Carolina Power & Light Company

August 2, 1978

BRUNSWICK STEAM ELECTRIC PLANT UNIT NOS. 1 AND 2
DOCKET NOS. 50-325 AND 50-324
LICENSE NOS. DPR-71 AND DPR-62
CONTROL OF HEAVY LOADS NEAR SPENT FUEL

FIGURE 1

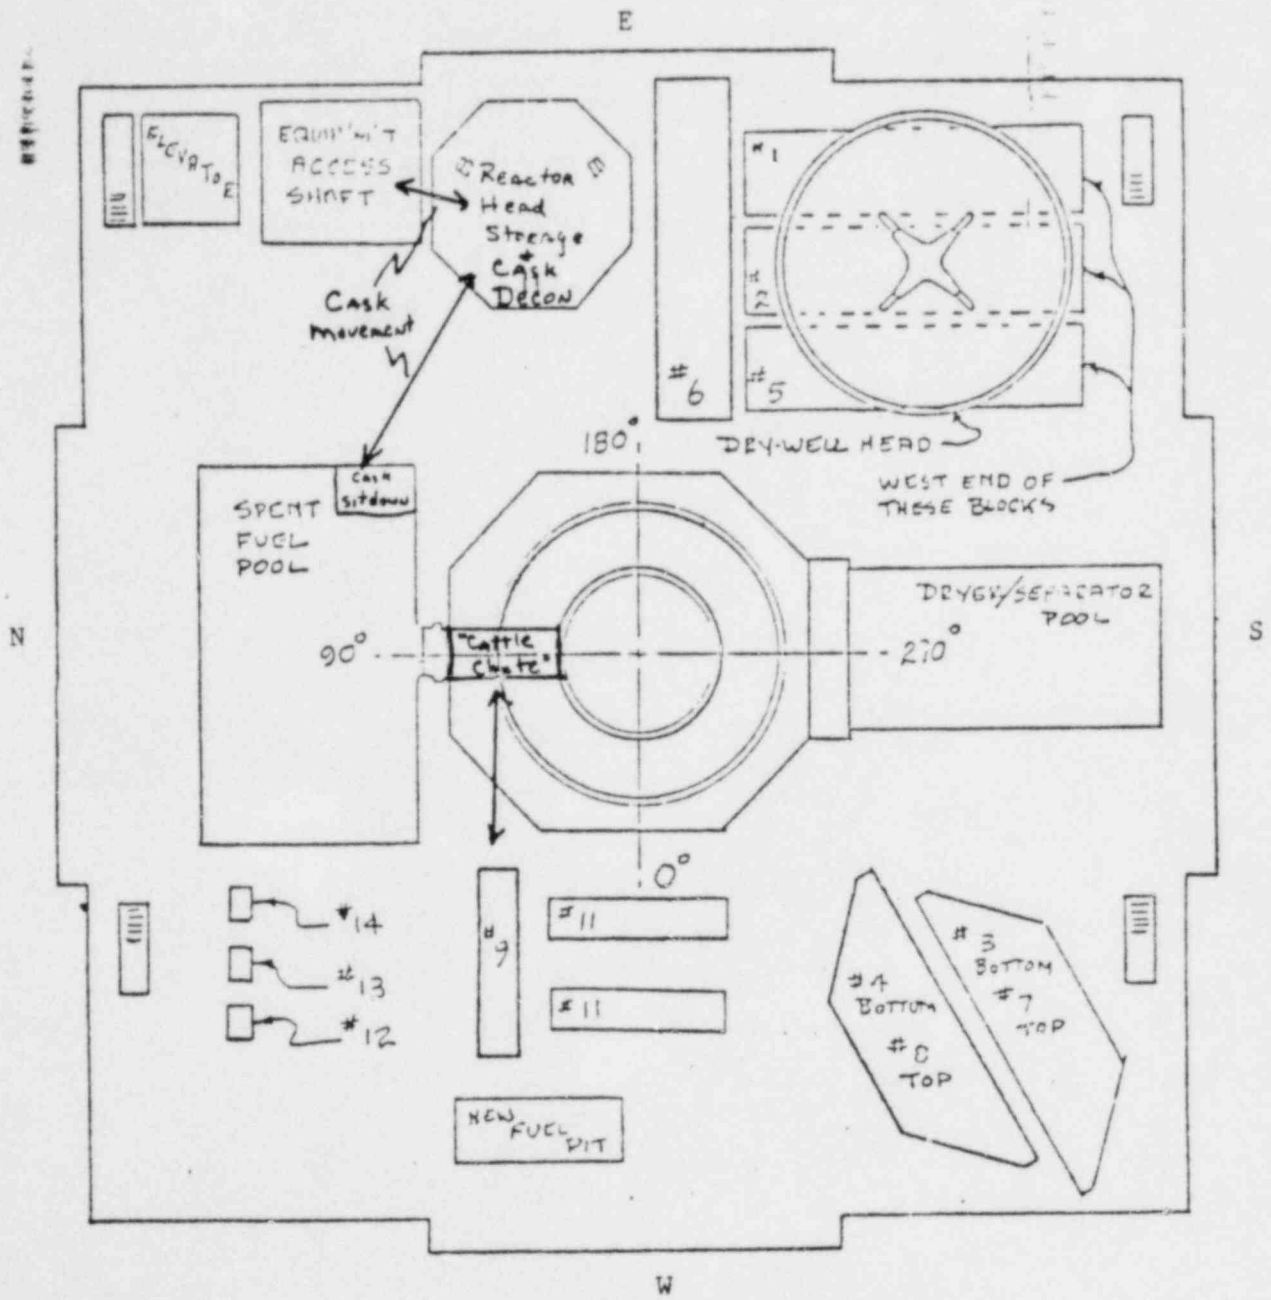
Question 1. Provide a diagram which illustrates the physical relation between the reactor core, the fuel transfer canal, the spent fuel storage pool and the set down, receiving or storage areas for any heavy loads moved on the refueling floor.

Response: Please see the attached Figure 1, which is representative of both units.

a. The drywell head which weighs approximately 85 tons is moved to the storage area shown in Figure 1. The head would be lifted six or seven feet above the operating floor.

- b. The reactor head which weighs 70 tons is moved to the storage area shown on Figure 1. The head would be lifted approximately four feet over the operating floor.
